**KINGSTON BUSINESS PARK**

**FINAL  
GENERIC  
ENVIRONMENTAL IMPACT STATEMENT**

Planning Board  
City of Kingston  
City Hall, 1 Garraghan Drive  
Kingston, New York 12401

## TABLE OF CONTENTS

# KINGSTON BUSINESS PARK CONCEPTUAL DEVELOPMENT PLAN

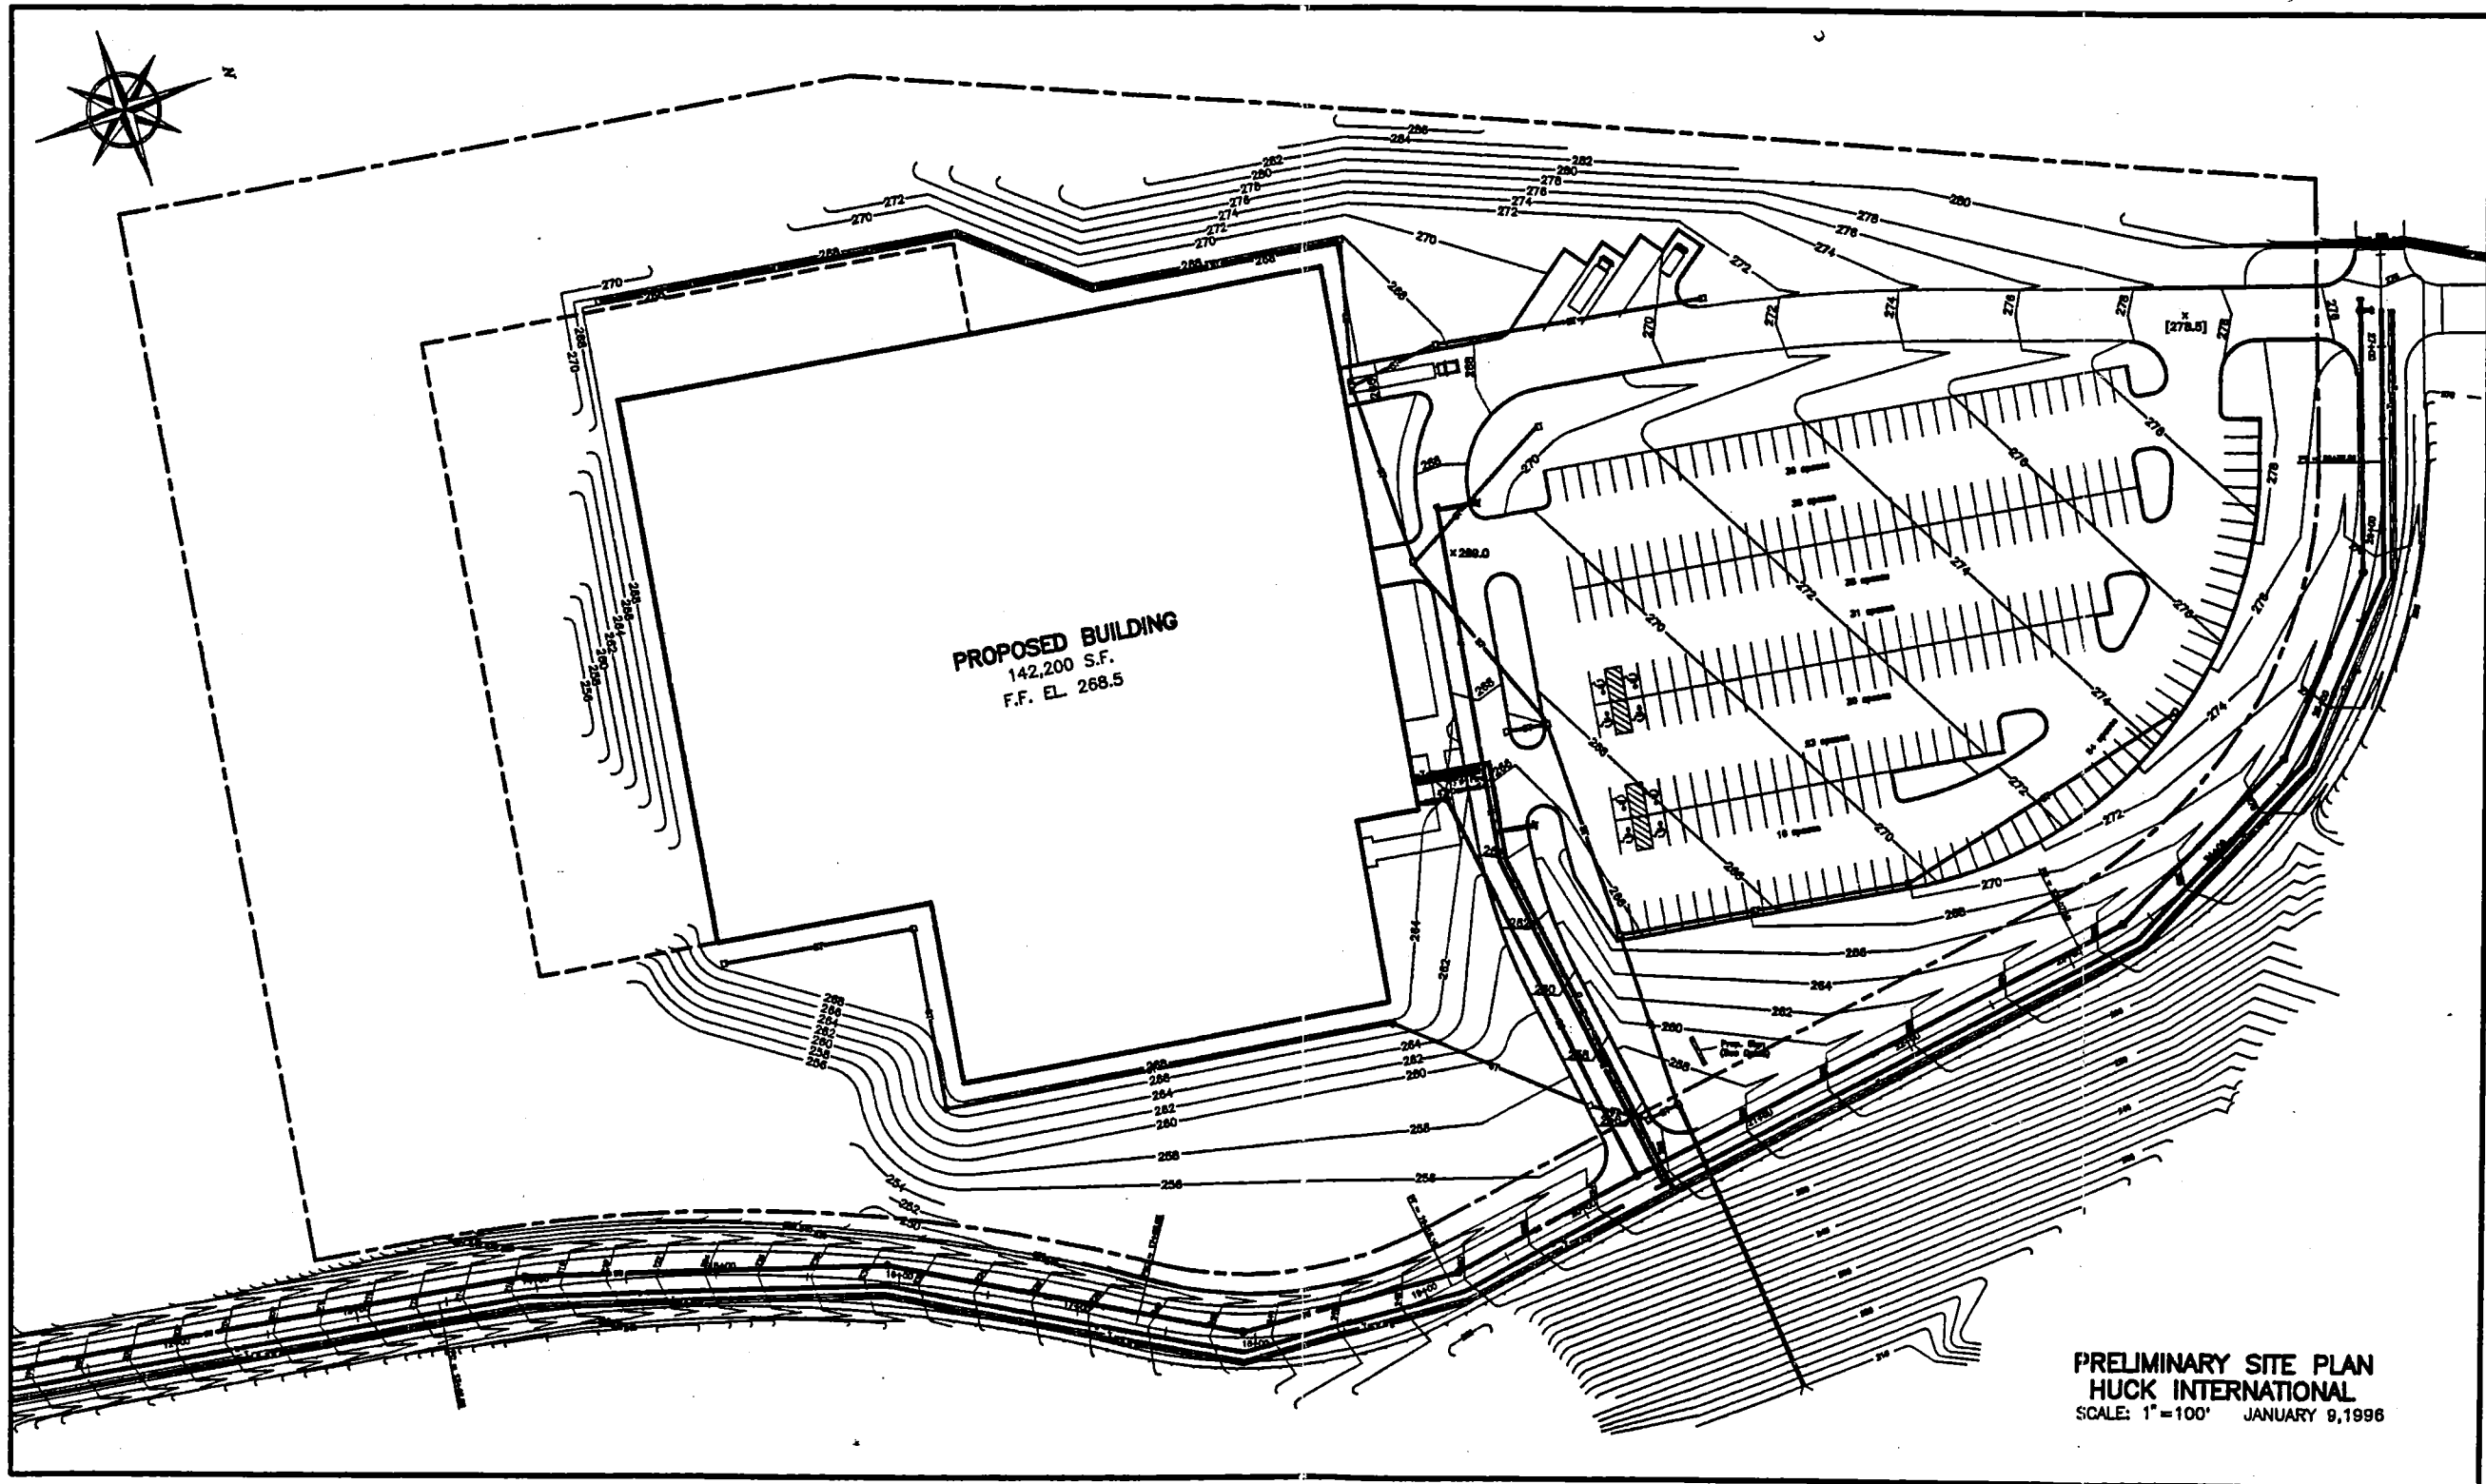
(Suzanne Cahill, City Planner)

**Response:** In order to ensure that an undisturbed buffer will be maintained above the steep slopes, the concept plan has been modified to reduce the size of the westernmost building and to move it approximately 75 feet from the edge of the steep slope (see Map No. 1, Revised Concept Plan). The park buffer area established by the Performance and Development Standards has been redefined (see Map No. 3) to reflect on-site topographic features and will have a minimum width of 125 feet behind the westernmost building, 50 feet of which is on top of the plateau. As shown on Map No. 3, a substantial area beyond the required buffer will also be undisturbed. Impacts from erosion will be further reduced since the ground above the slope will be undisturbed. Visual impacts will be further mitigated since it will now be possible to maintain a natural, vegetated barrier between the westernmost building and the steep slope.

**Response:** Including the buffer zone, a total of some 54 acres (over half of the site) will remain undisturbed (see Map No. 3). Modifications to the Concept Plan (Map No. 1) will preserve a vegetative border on the western edge of the site and along most of the eastern edge as well. In addition, every effort will be made during site planning to preserve existing vegetation within development sites. These modifications and site planning techniques will minimize the creation of unnatural "notches" along the ridge line, as viewed from the Hudson River to the east and existing neighborhoods from the west.

**MAP NO. 3**

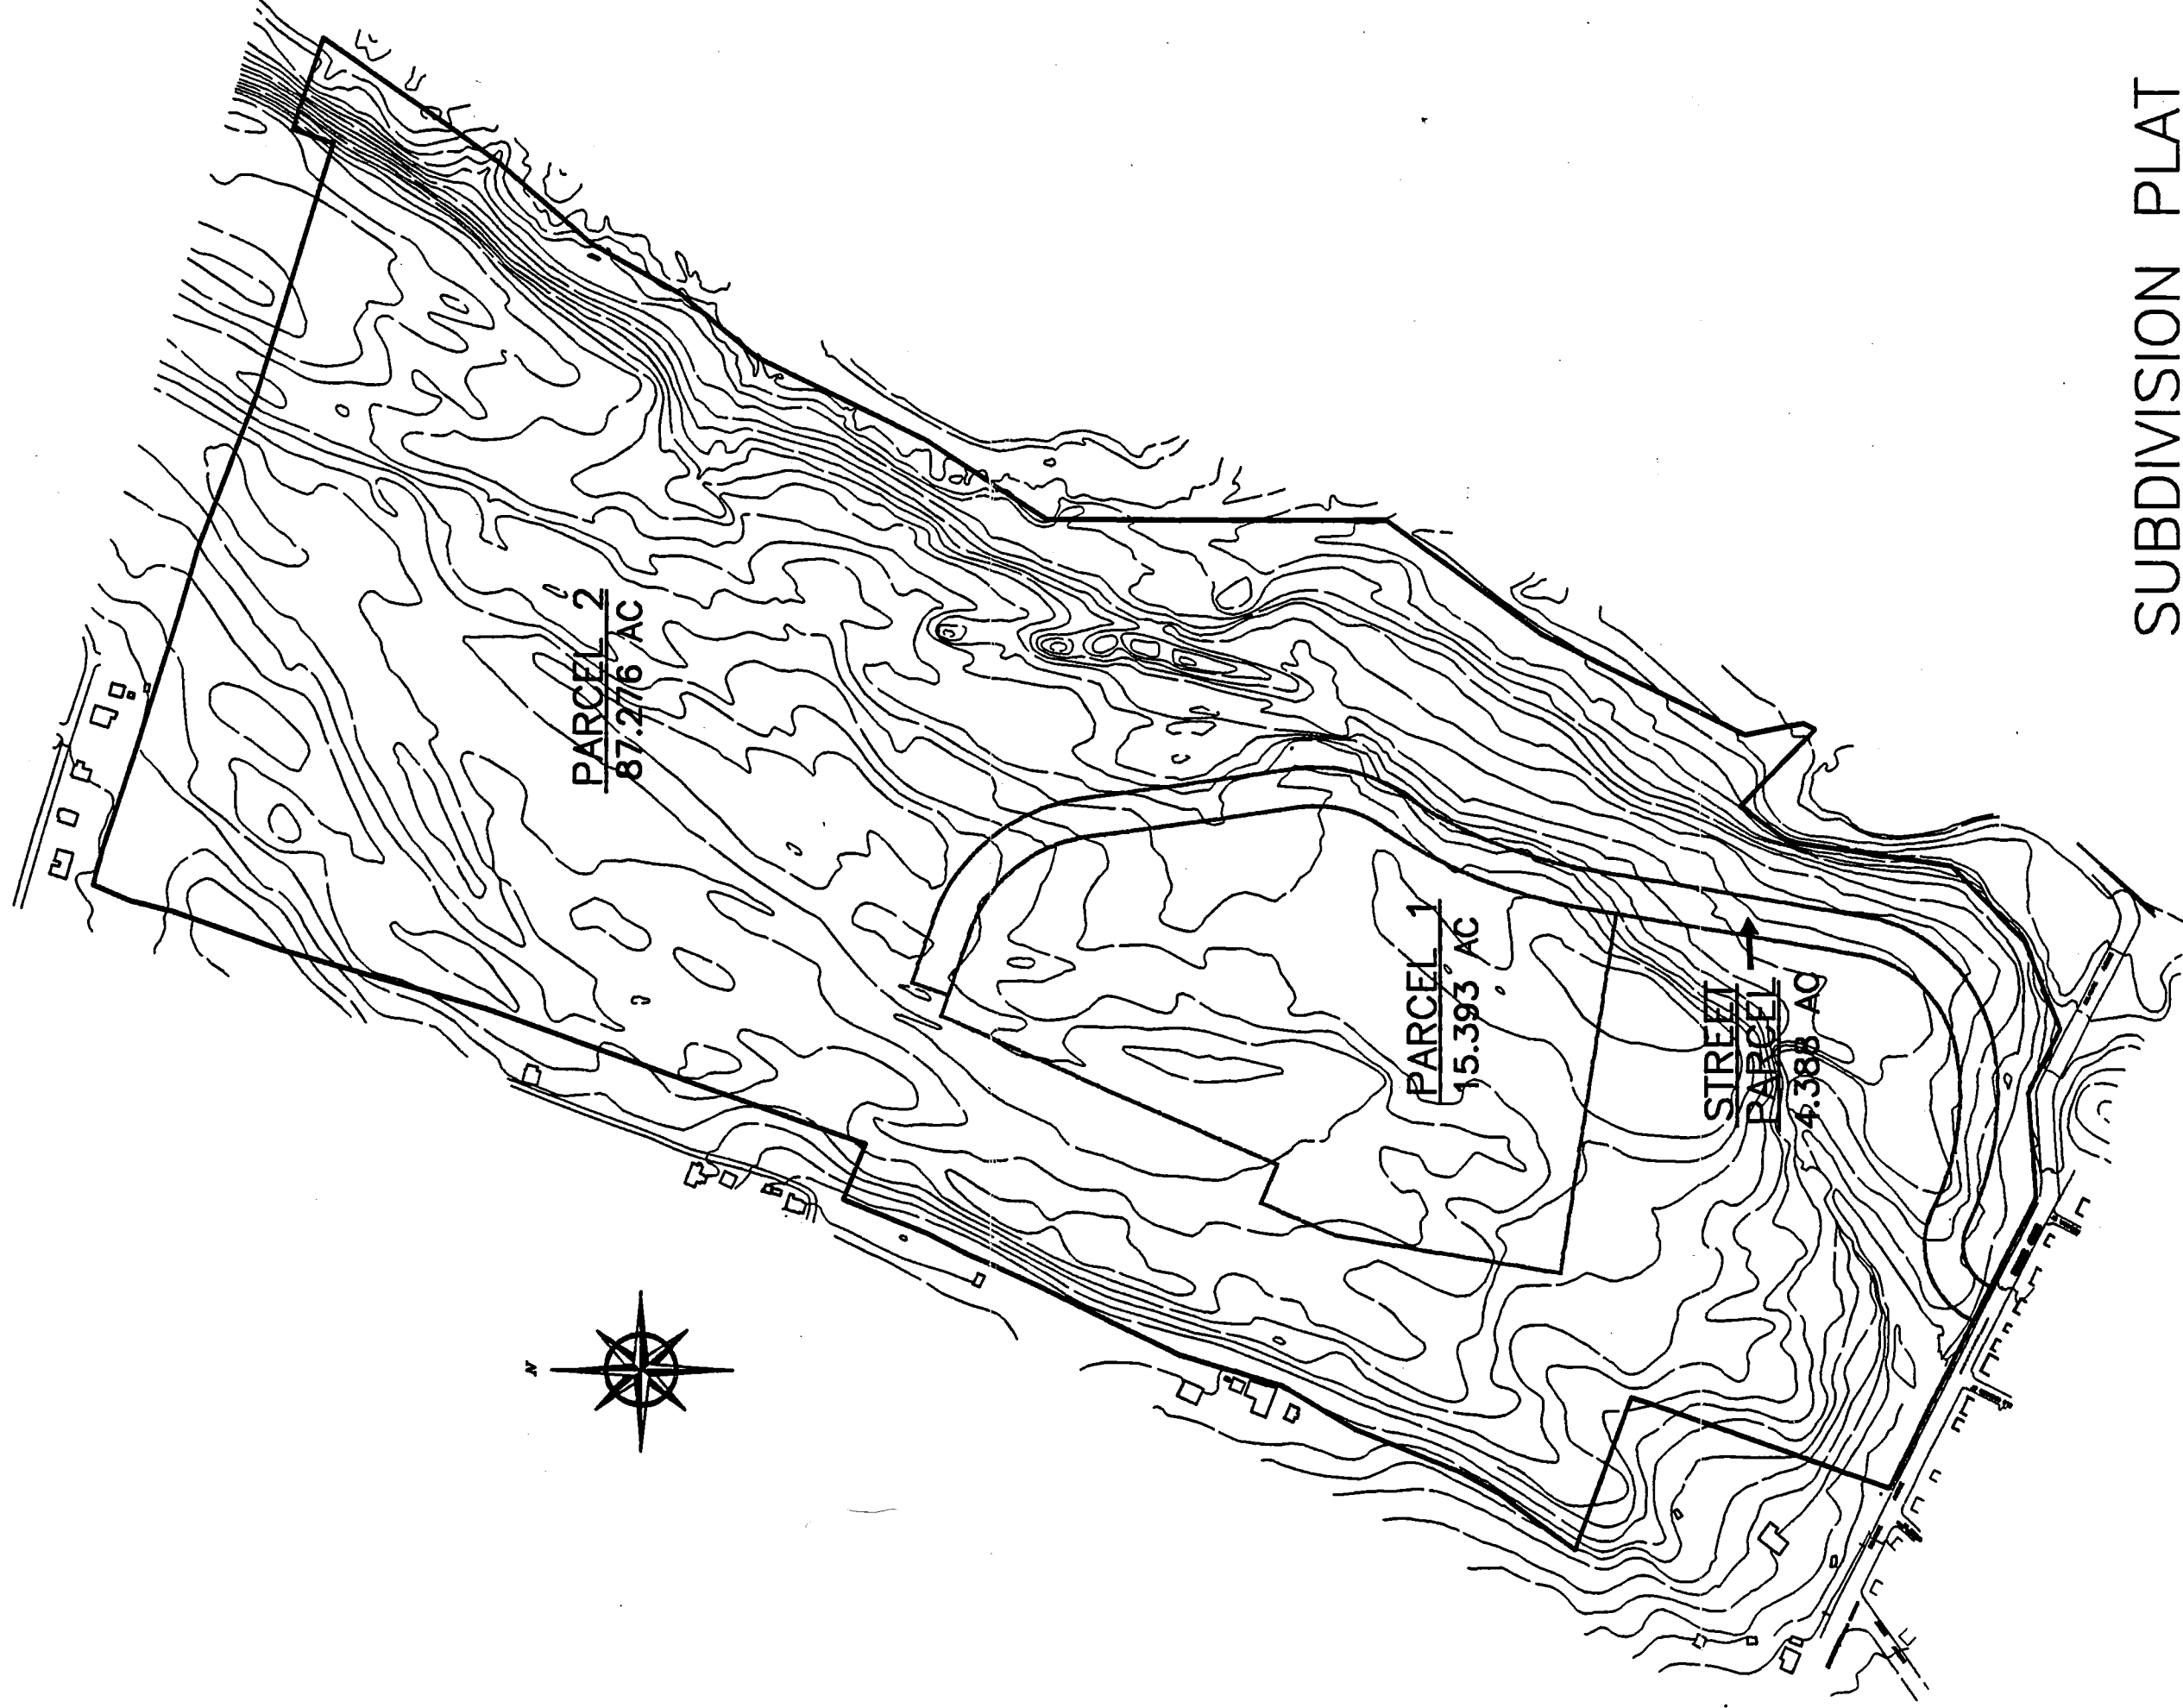
- 1. The buffer area limits should be expanded and revised.**  
(Dennis Doyle, UCPB; Suzanne Cahill, City Planner; Pat Vaselewski)

**Response:** Site clearance will take place on the basis of an approved site plan. No clearing will take place within the "non-disturbance area" illustrated on Map No. 3. In addition to inspections normally carried out by the Building Inspector's office, the KLDC will monitor all construction on a regular basis.

**Response:** The only possible wetland on the site is located in the northwest corner, as shown on Map No. 3. This area is less than one quarter acre in size and has been included in the defined buffer area and will not be disturbed.

**Response:** The buffer zone which surrounds the Business Park has been revised and substantially expanded, as illustrated on Map No. 3. The buffer area boundary follows site features and topography and ranges in width from a minimum of 100 feet to over 600 feet. The area within the buffer zone includes a total of 41 acres, or 38% of the total 107 acre site.

SECTION A-A'

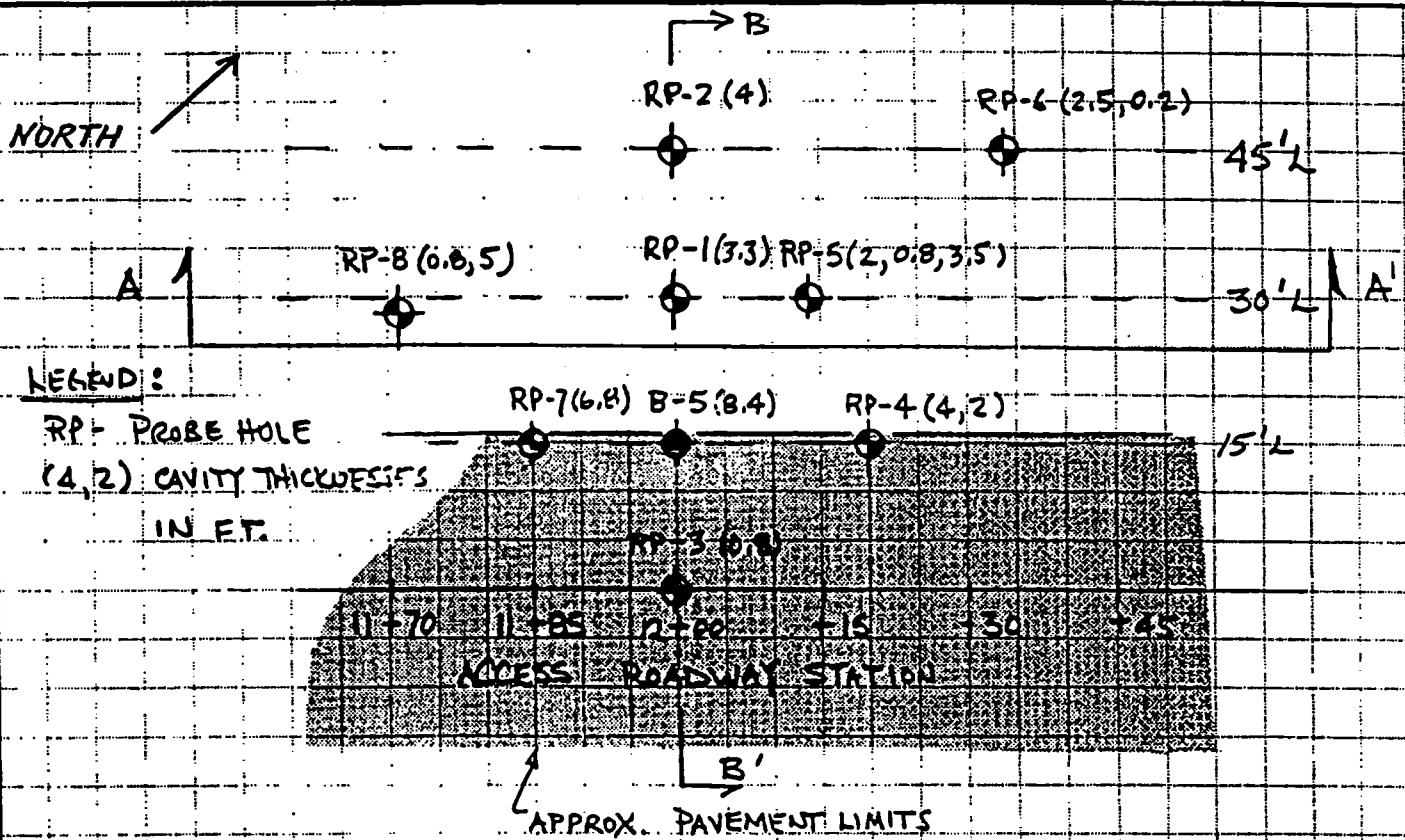
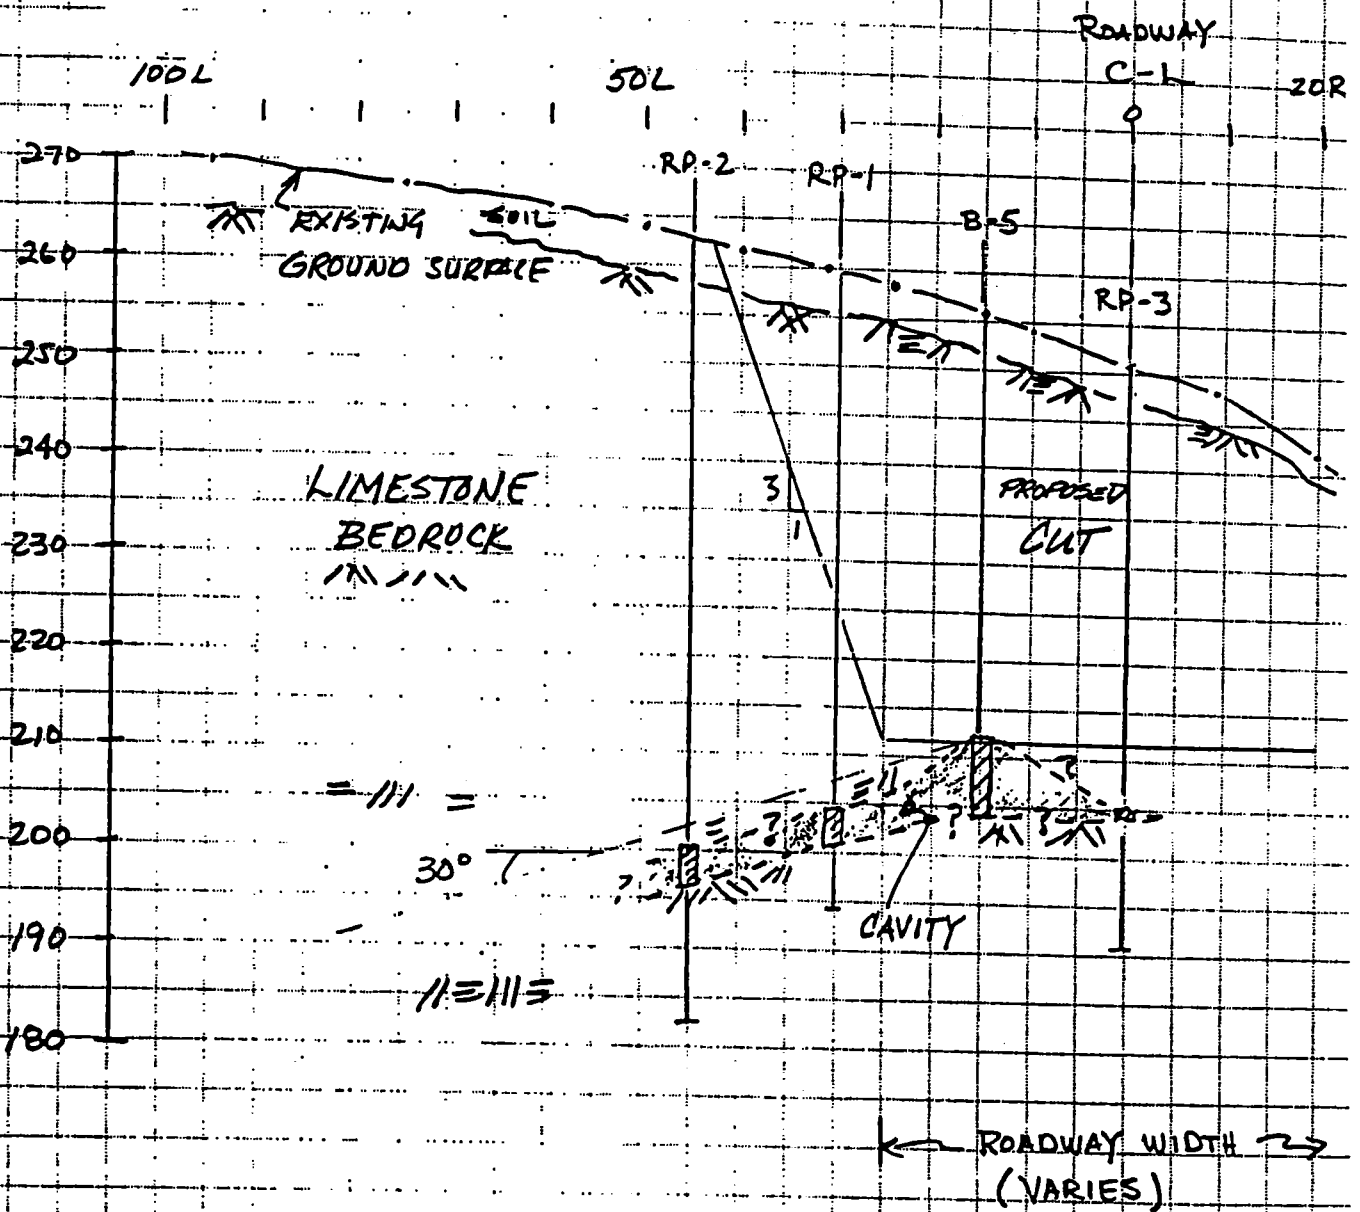
**Response:** The site of the proposed development is partially underlain by man-made caverns from which limestone was excavated to manufacture cement. In order to determine if the areas of the site proposed for development of roadways or buildings were safe and to determine if the project was feasible to construct, GeoDesign, Inc., P.C., a professional geotechnical firm was retained to conduct concurrent engineering and feasibility tests and studies necessary to formulate a site development plan for the site. A primary method of analysis required subsurface investigation by test borings to determine the extent and location of the caverns.

Cavities are expected to be encountered in the deep excavations made for the roadway in this area. Although such cavities were not encountered in other test borings at the site, cavities may be encountered in other areas during excavation.

The extent of the cavities could be mapped in advance of construction with an extensive program of additional probes. Alternatively, actual conditions can be addressed with contingency plans to be implemented as needed during construction.

In either case, design plans and specifications should include provisions for local slope stabilization measures (e.g. concrete infill, concrete pillar supports) to address field conditions encountered during construction. Where the cavities appear just below the roadway similar measures should be employed to fill cavities in the subgrade.

We recommend that an experienced field engineer be on-site during the roadway excavation to observe actual conditions and make recommendations regarding remedial measures.
